Proposed Changes to Support 100G and 200G BiDi PHYs in Clause 157

P802.3dk TF August 2023 Zoom Meeting

Proposed changes to Clause 157

Figure 157-1—Architectural positioning of Multi-Gigabit Ethernet BiDi PHYs

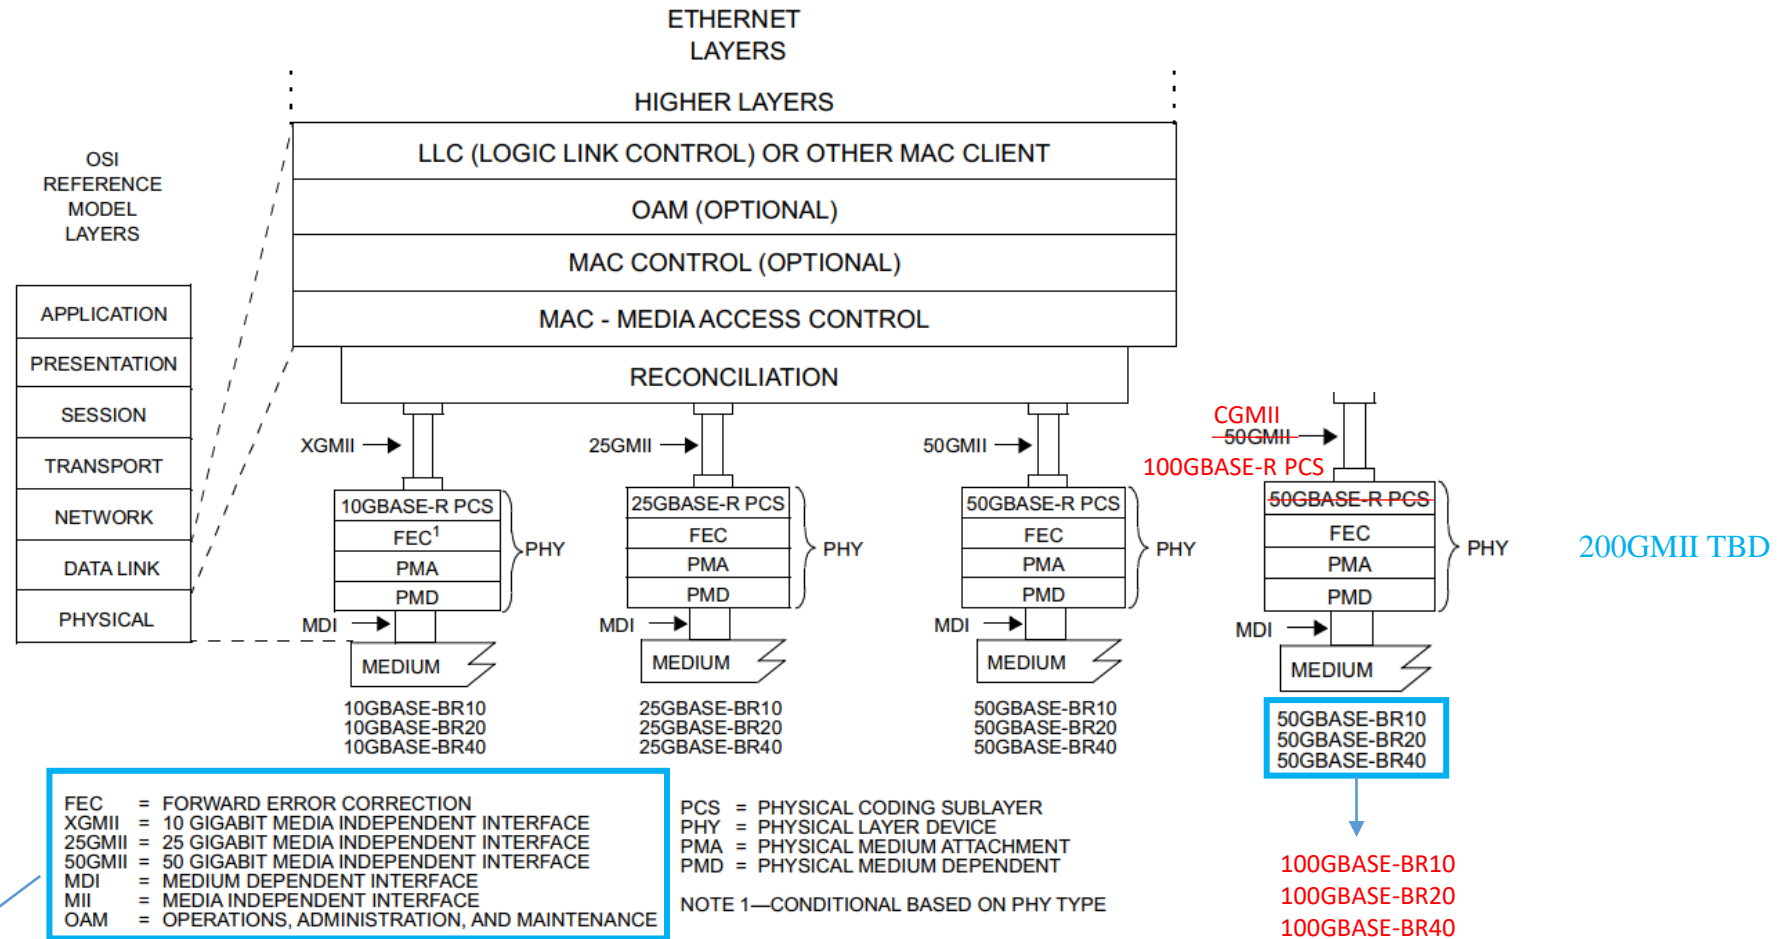
- FEC = FORWARD ERROR CORRECTION
- XGMII = 10 GIGABIT MEDIA INDEPENDENT INTERFACE
- 25GMII = 25 GIGABIT MEDIA INDEPENDENT INTERFACE
- 50GMII = 50 GIGABIT MEDIA INDEPENDENT INTERFACE
- CGMII = 100 GIGABIT MEDIA INDEPENDENT INTERFACE
- MDI = MEDIUM DEPENDENT INTERFACE
- MII = MEDIA INDEPENDENT INTERFACE
- OAM = OPERATIONS, ADMINISTRATION, AND MAINTENANCE
